## Addendum #3

**Project Name:** Cattle National Bank & Trust - Fallbrook  
6550 Merchant Drive  
**Project No.:** 12054  
**Issued:** May 09, 2013  
**Bid Date:** 2:00 pm, CDT May 14, 2013

**C4.01**

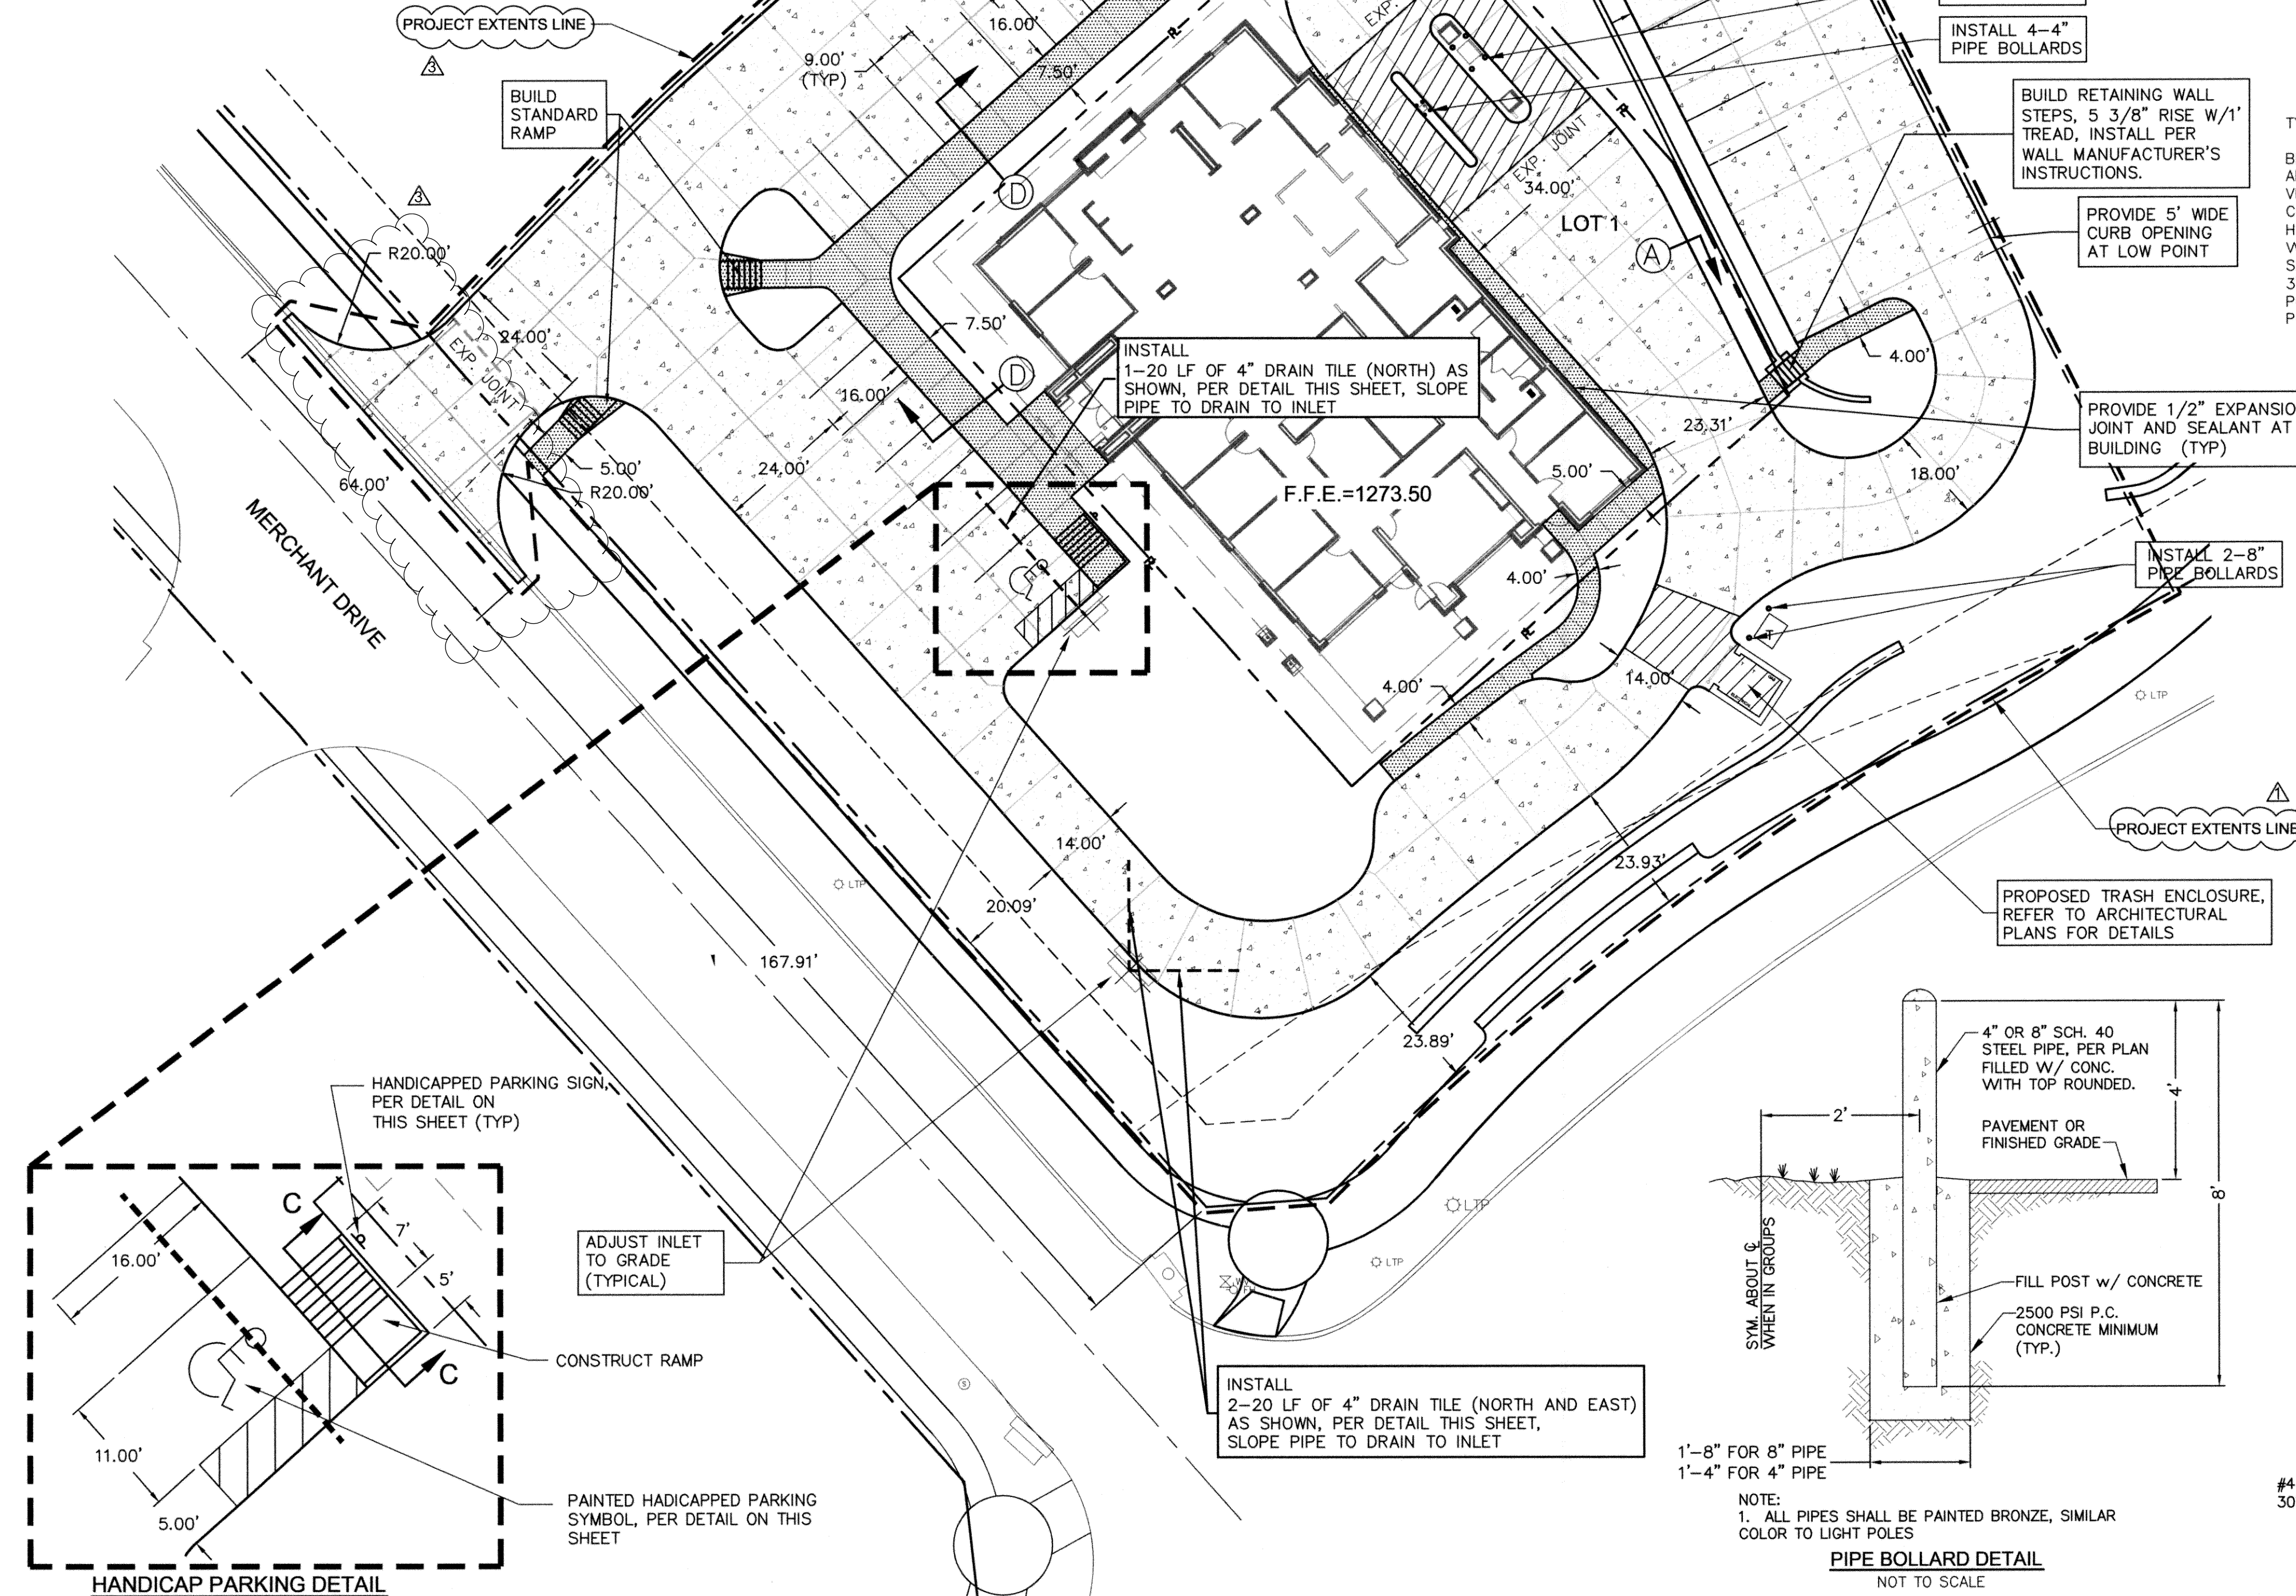
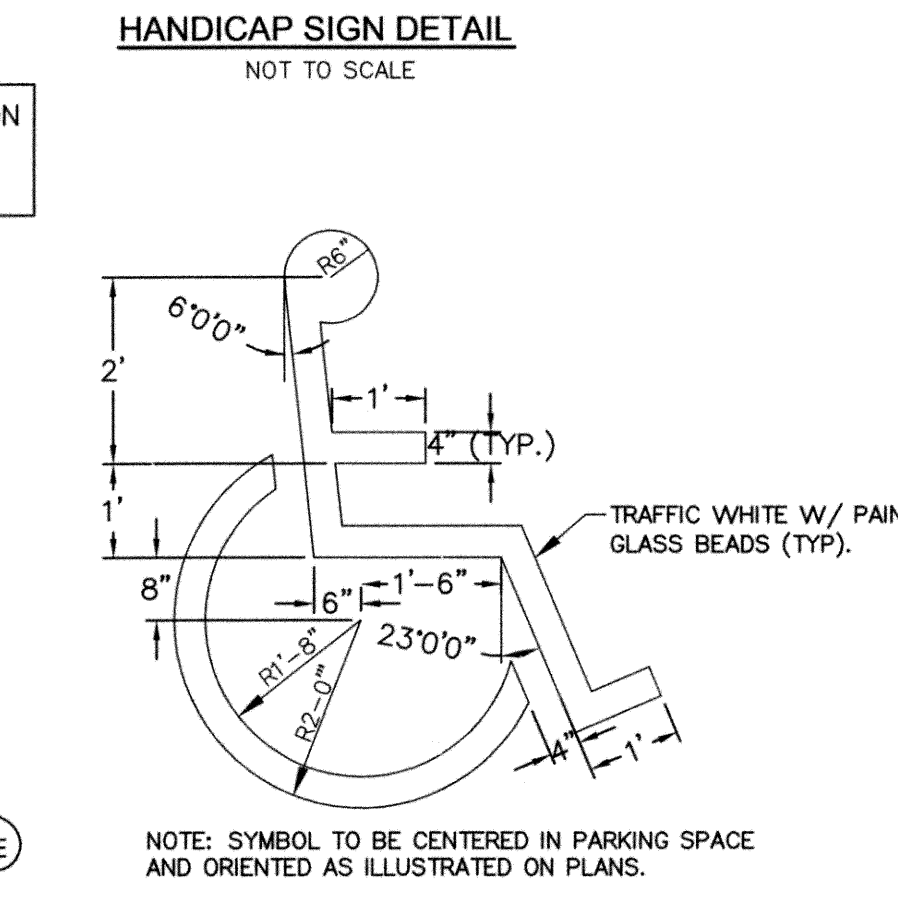
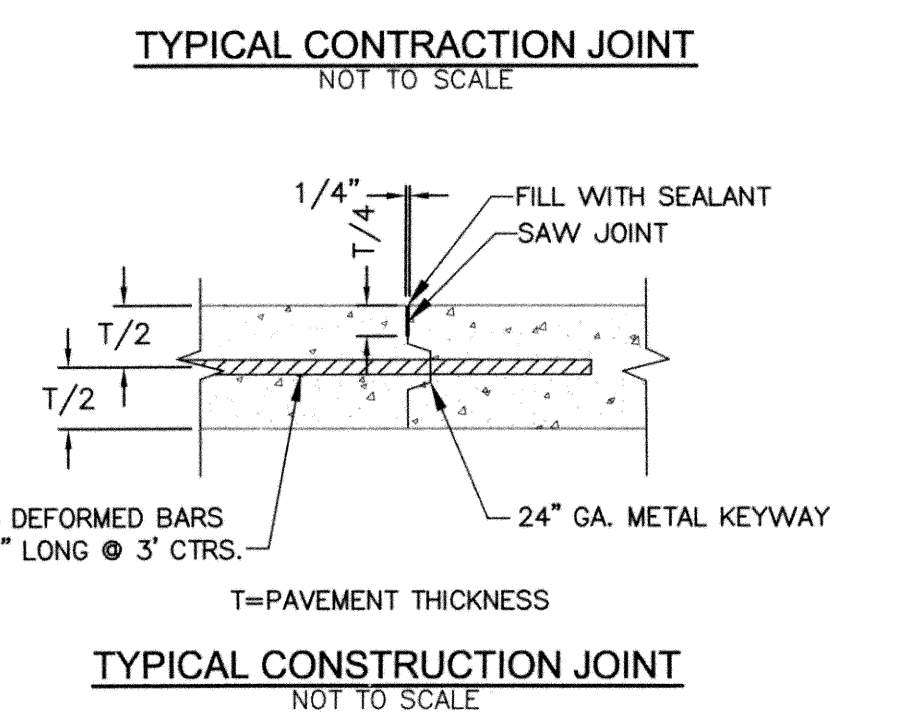
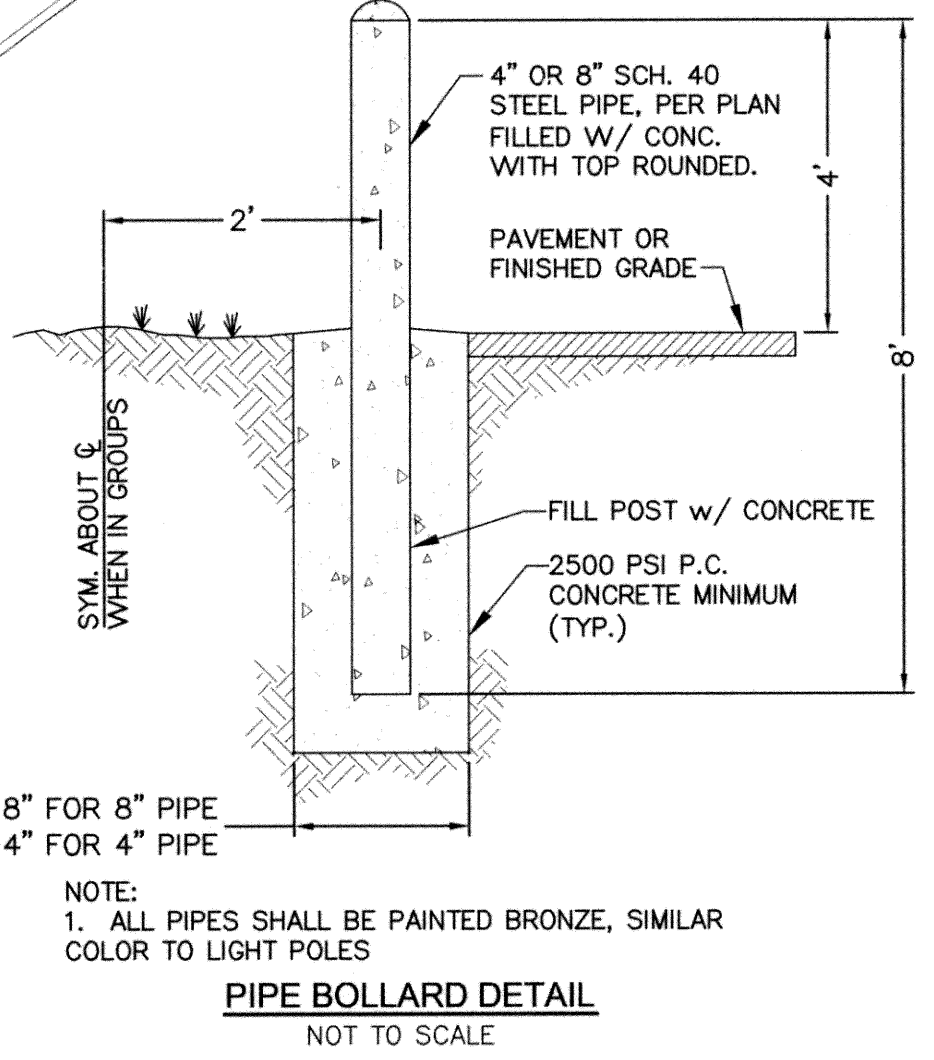
- a. Labeled Project Extents Line and Property Line. Project Extents line modified. Added drain tile detail and modified the curb and gutter detail.

<b>Cattle National Bank &amp; Trust</b>		Sinclair Hille Architects 700 Q St. Lincoln, NE 68508	<b>aS-10</b>
Engr Project No. 12078	Date: 05/08/13		
SCALE: 1/8" = 1'-0"	Drawn By: mwo		Ref Sht: S100

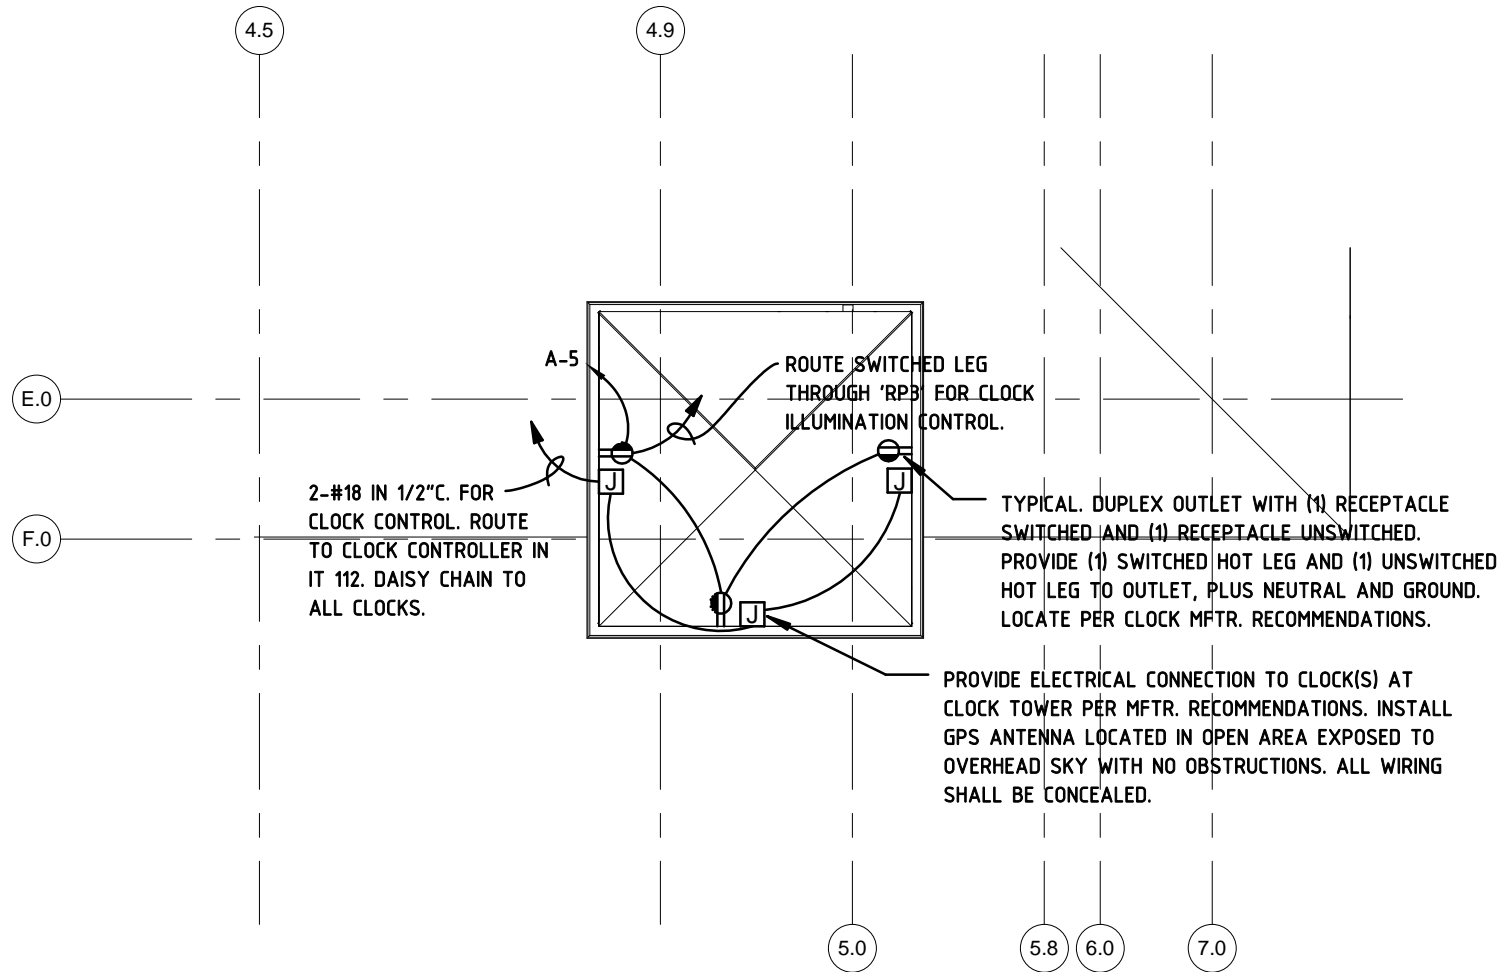
- a. Refer to sketch aS-10 for revision to foundation plan. No structural stoop was indicated at the main entry. This information has been added.

PLAN NOTE 4: STRUCTURAL STOOP-SEE THIS SHEET FOR SLAB THICKNESS & REINF
